CONTRACT NO: 008625 FEDERAL AID NO: ER-NHPP-0520 (053)
 CONTRACT TITLE: SR 520, MONTLAKE TO EVERGREEN PT. BRIDGE WEST APPR
 CHANGE ORDER NO: 115 DELETE FACILITY M

This change order deletes the Constructed Stormwater Treatment Wetland (CSTW) Facility M located southeast of East Park Drive E and north of SR 520 mainline and provides modified details for this area.

This change order also eliminates Wall 9 and the scupper blocks for concrete barriers on WABN.

ROADWAY SECTION P

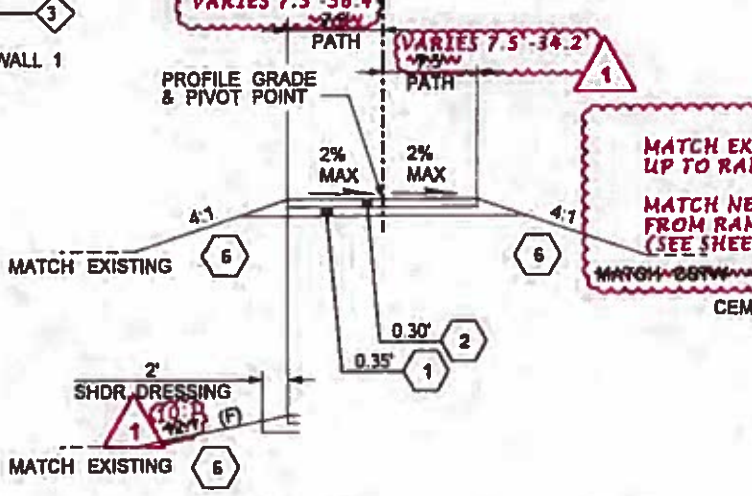
~~RAMV STA. 9+27.51 TO RAMV STA. 20+14.37~~
~~P. FROM RAMV STA. 11+84.00 TO RAMV STA. 14+66.00~~
 F. FROM RAMV STA. 11+56.00 TO RAMV STA. 14+00.00

WALL 9 LAYOUT

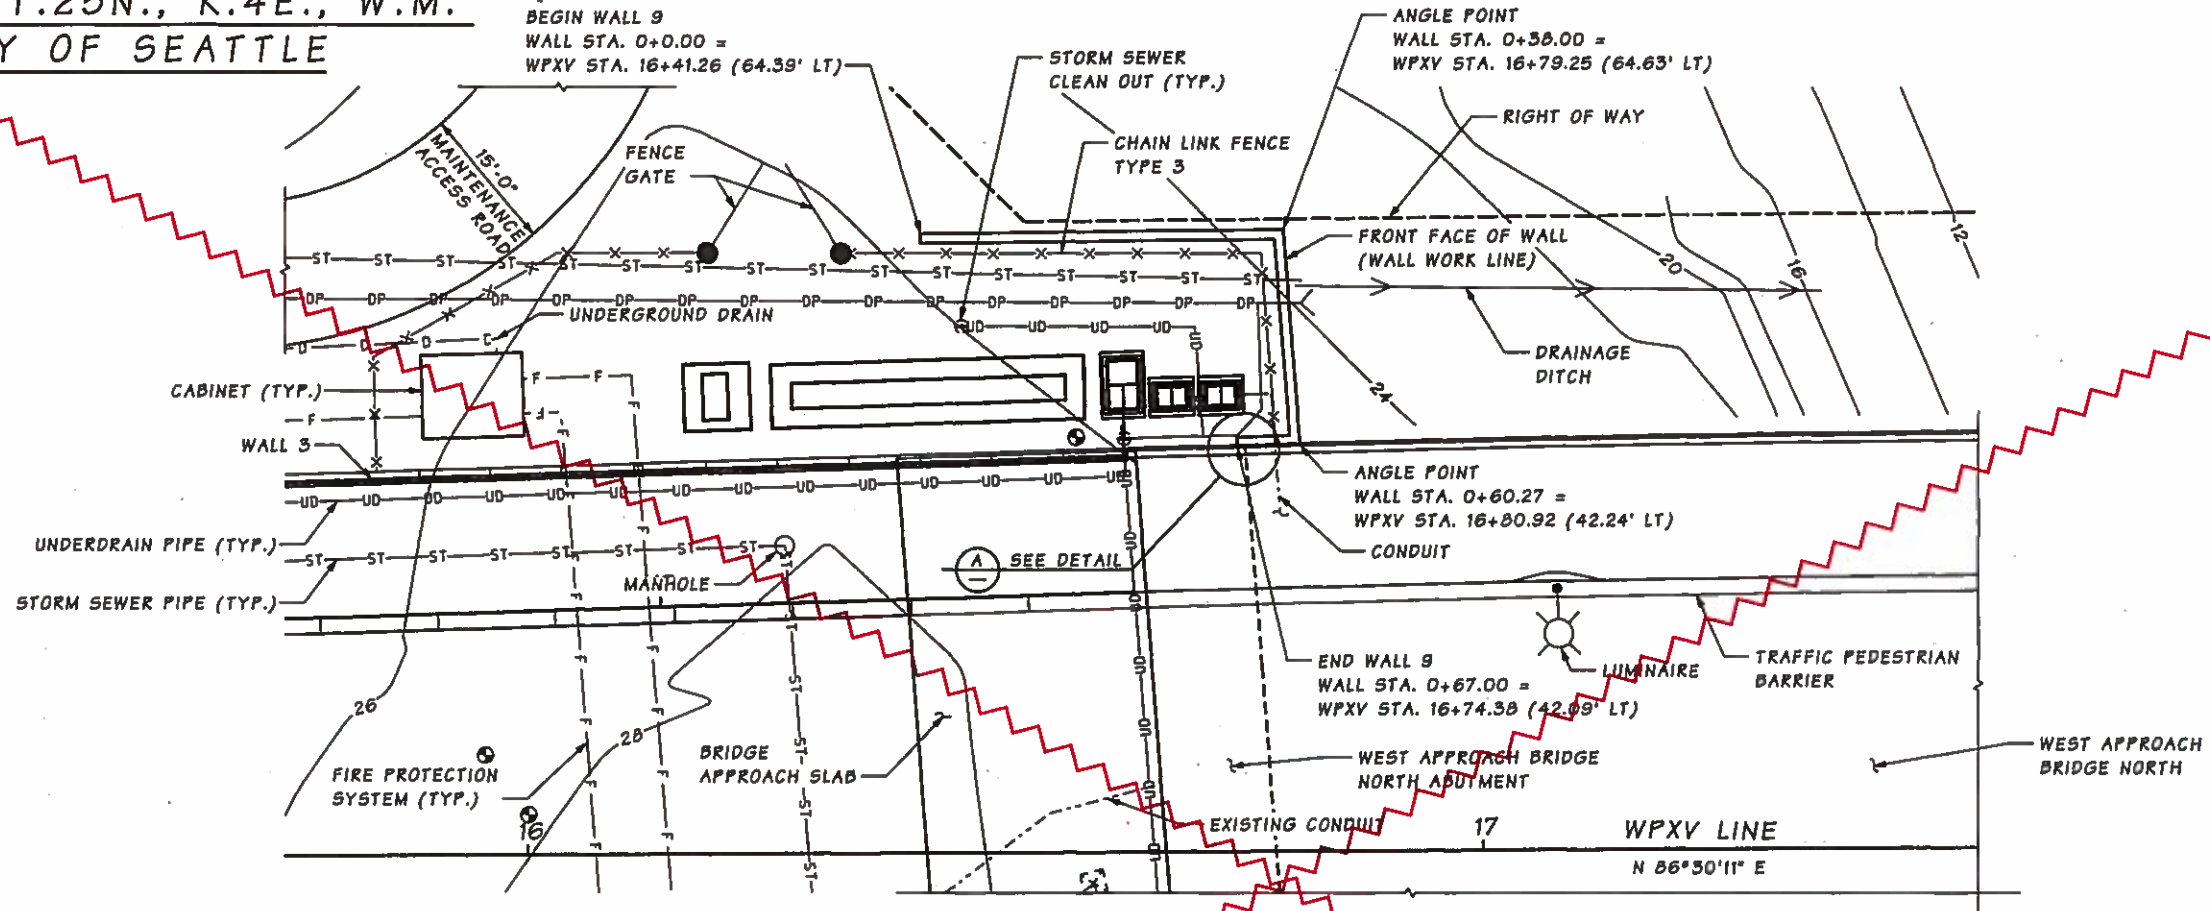
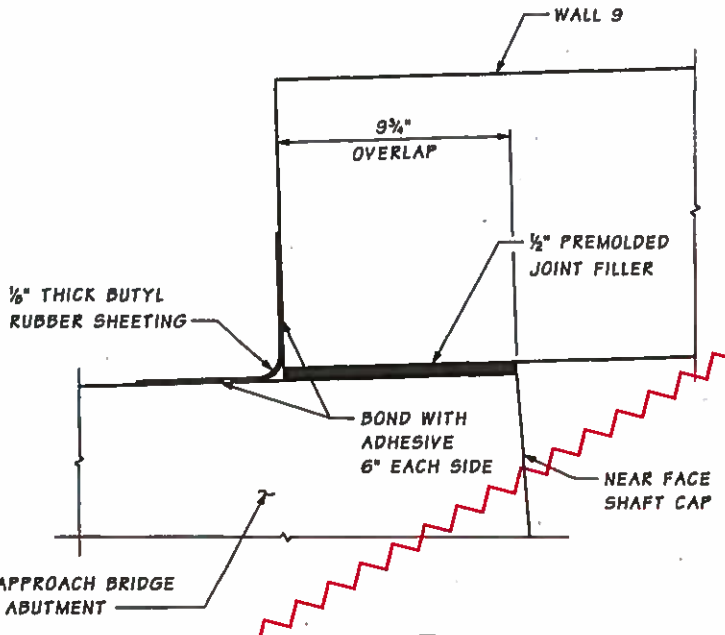
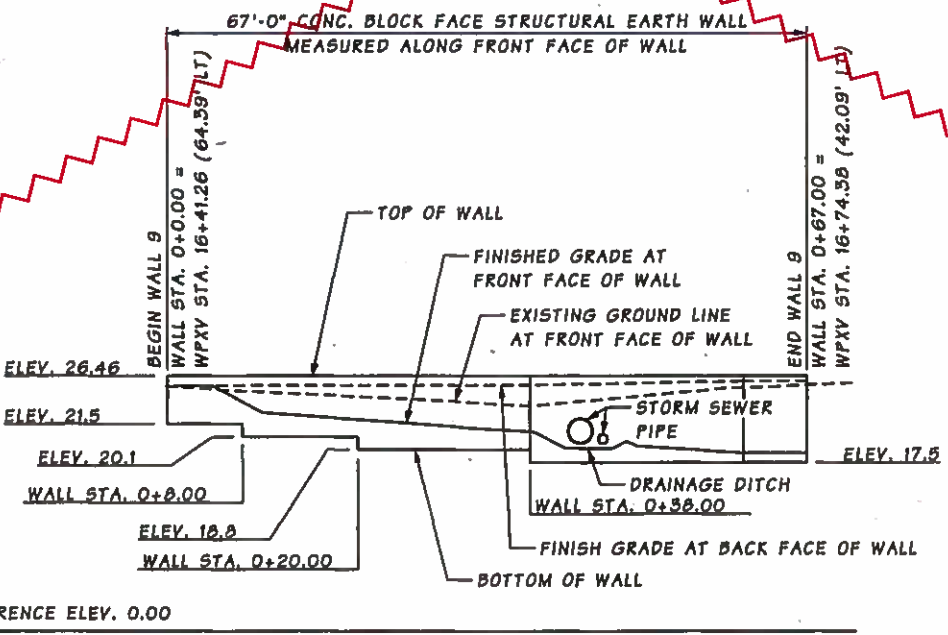
3. As a result of the deletion of the CSTW, other modifications being made to Pier 1 in Change Order 103, and construction staging for future projects, Retaining Wall 9 no longer needs to be constructed. That wall is deleted from the Contract in this change order.

Contract 8625
Change Order #115
Page 68 of 72
BARRIER SCUPPER BLOCK

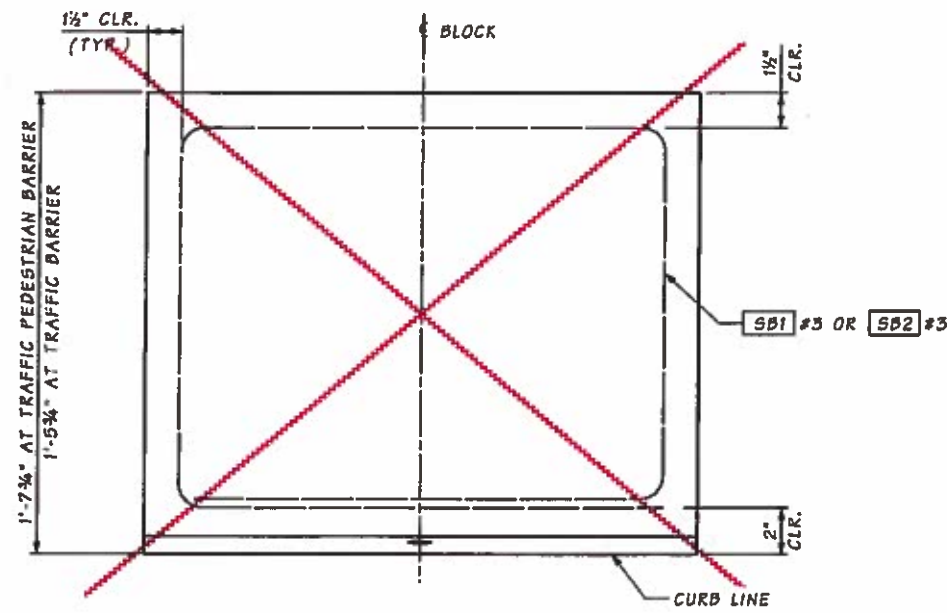
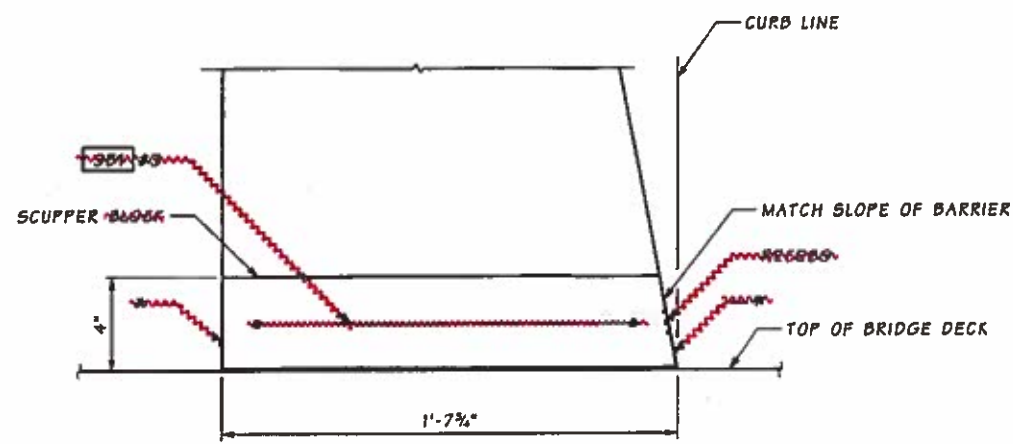
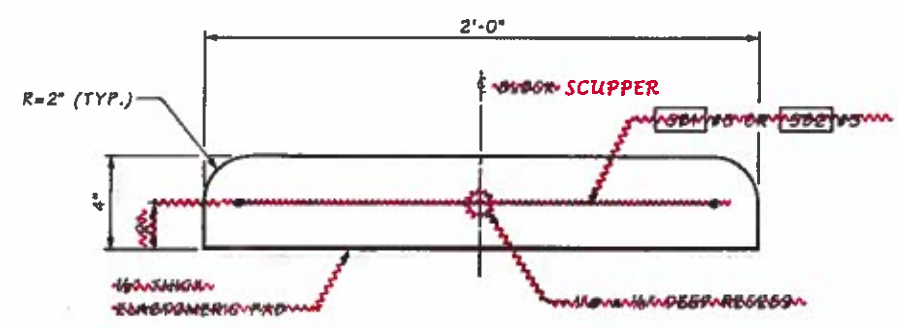
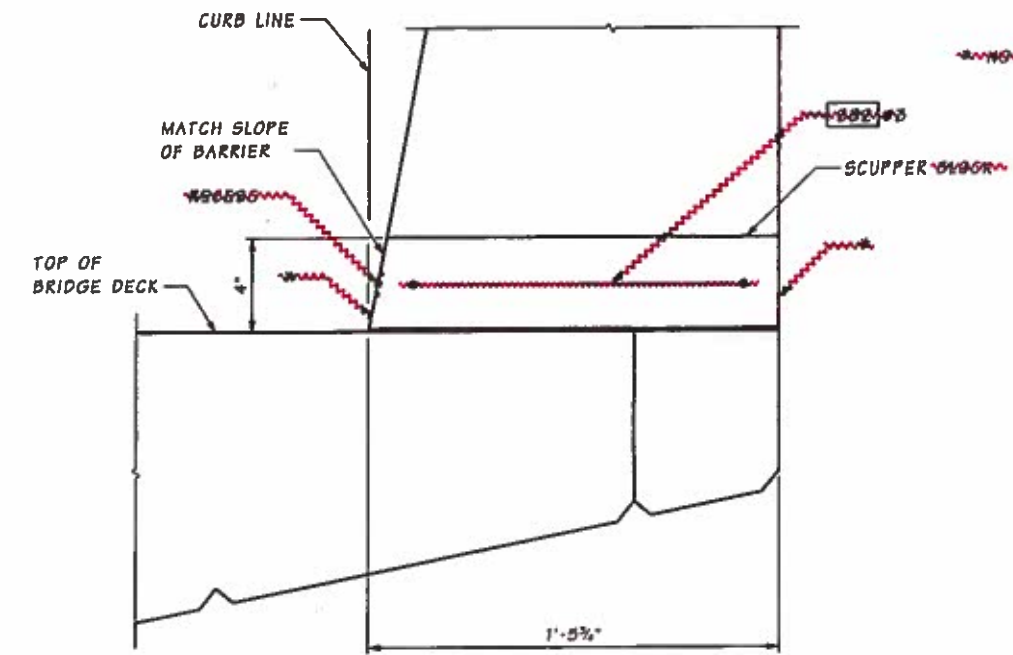
~~PLAN SCUPPER BLOCK~~
